DOCKETED	
Docket Number:	23-OPT-01
Project Title:	Fountain Wind Project
TN #:	263364
Document Title:	California Wildlife FoundationCalifornia Oaks Comments - Fountain Wind Project, Docket Number 23-OPT-01, Staff AssessmentDraft Environmental Impact Report
Description:	N/A
Filer:	System
Organization:	California Wildlife Foundation/California Oaks
Submitter Role:	Public
Submission Date:	5/27/2025 11:03:10 AM
Docketed Date:	5/27/2025

**Fountain Wind Project, Docket Number 23-OPT-01, Staff
AssessmentDraft Environmental Impact Report**

RE: Fountain Wind Project, Docket Number 23-OPT-01, Staff Assessment/Draft Environmental Impact Report

RE: Draft Environmental Impact Report (DEIR) for the proposed project identified as the Fountain Wind Project (Use Permit 16-007)

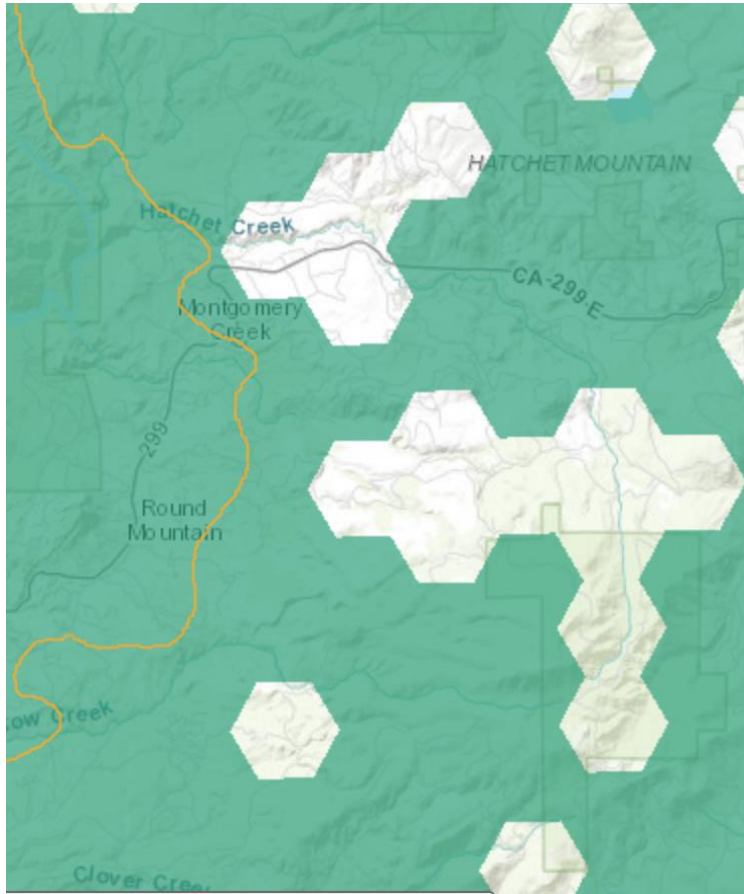
The screenshot below was created utilizing the Department of Fish and Wildlife's Areas of Conservation Emphasis mapping tool (<https://apps.wildlife.ca.gov/ace/>). The green hexagons are mapped as oak:

Figure 3.4-1
Natural Vegetation Communities Found within the Project Site

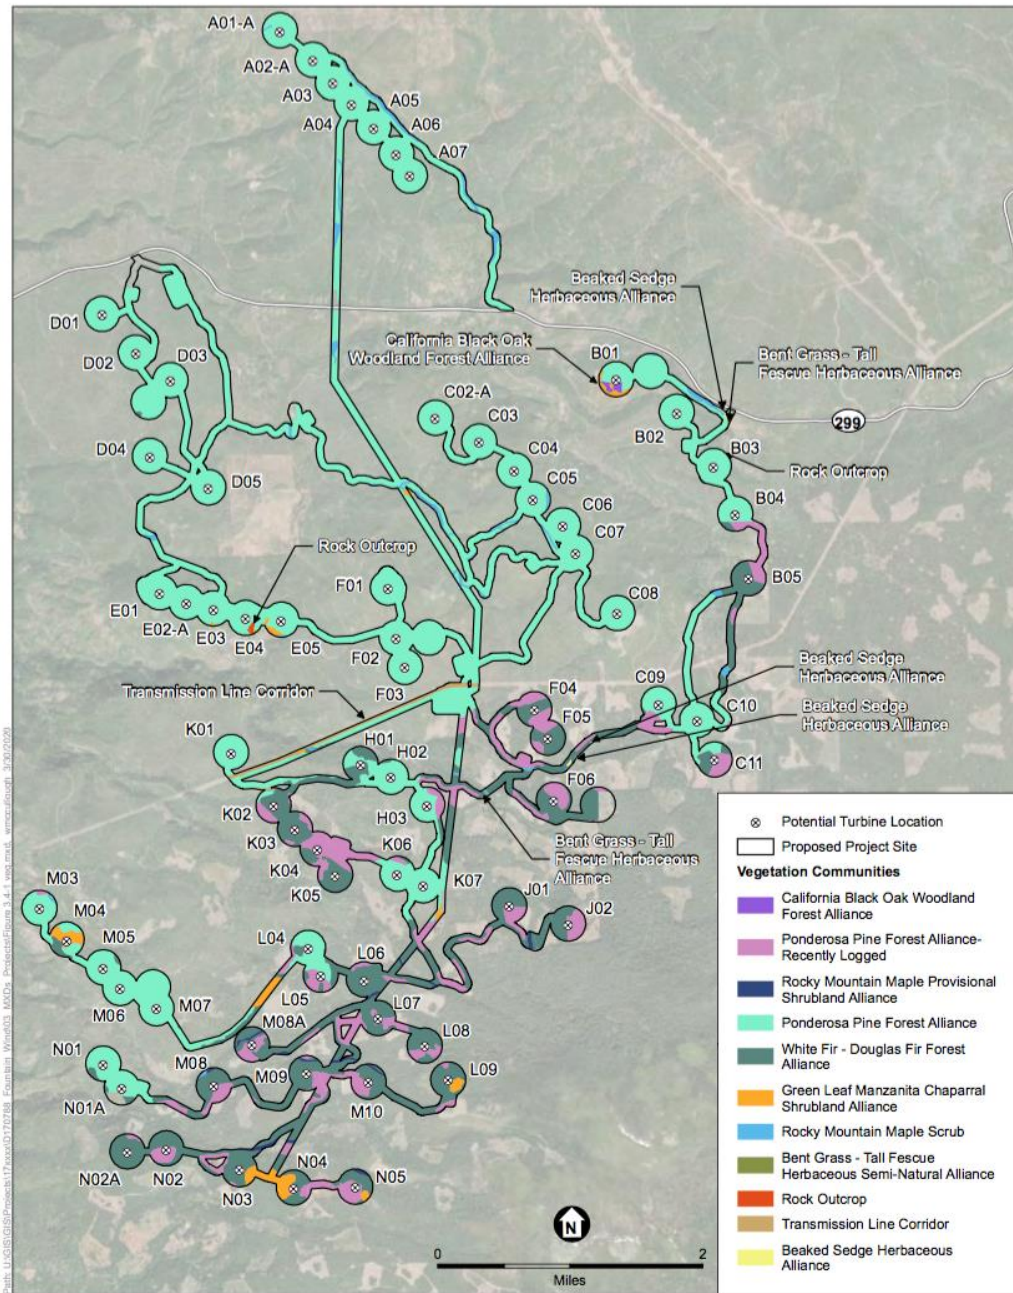
Figure 3.4-1, Natural Vegetation Communities Found within the Project Site presented on page 3.4-5 of the DEIR, and reproduced in Attachment 1 of this letter, only shows vegetation communities proximate to turbines and roads. It is ludicrous to assume that project impacts are limited to the *immediate* vicinity of the project infrastructure. The DEIR's Project Overview (ES.2.1.) states: "The Fountain Wind Project is a renewable wind energy generation development proposed on approximately **4,464** acres in unincorporated Shasta County (Project Site)," whereas page 1 of the Executive Summary of Appendix C, Biological Resources, states: "The proposed Project encompasses approximately **32,600** acres (50.9 square miles) of private land in central Shasta County." By confining the analysis to 4,464 acres rather than 32,600 acres, many of the project impacts are not properly assessed. The removal of habitat to accommodate project infrastructure will impact habitat connectivity over an area greater than 4,464 acres.

Table 3.4-1, Natural Vegetation Communities Present and Area within Project Site and Alternatives, lists the project site as 4,373.1 acres, and it shows project impacts on 5.5 acres of oaks (California Black Oak Woodland) under Alternative 1 and no impacts under Alternative 2. The DEIR must identify all of the impacted oaks on the site and address the retention requirements addressed in the discussion of the California Board of Forestry and California Fish and Game Commission Joint Policy on Hardwoods, which follows on page 3 of this letter.

Attachment 2

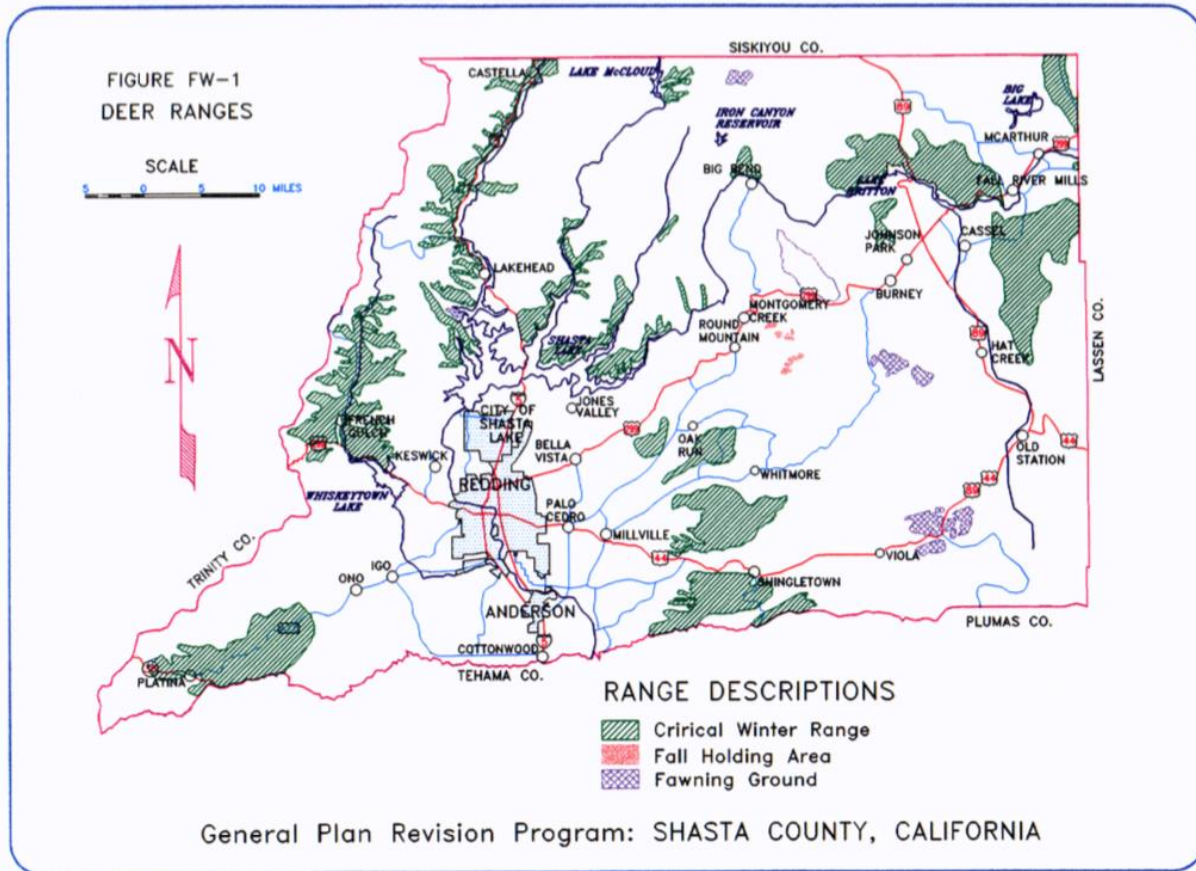
The map in Attachment 2 of this letter, Figure FW-1, *Deer Ranges*, shows much of the project site is a *fall holding area* for deer. If the project were to go forward, the environmental analysis and associated mitigation approach would need to address the requirements discussed in the Joint Hardwood Policy. The DEIR has a number of discussions of deer populations, with discussion of possible interactions with project infrastructure. It needs to also include analysis of proposed project impacts on hardwoods with consideration for deer populations given that the habitat fragmentation impacts extend from the roadways, turbine towers, and other associated infrastructure. Any other hardwood impacts in the 32,600-acre footprint of the project should also be assessed, and mitigation—the DEIR currently has no mitigation for hardwood impacts—should also be calculated based on the project’s full impacts.
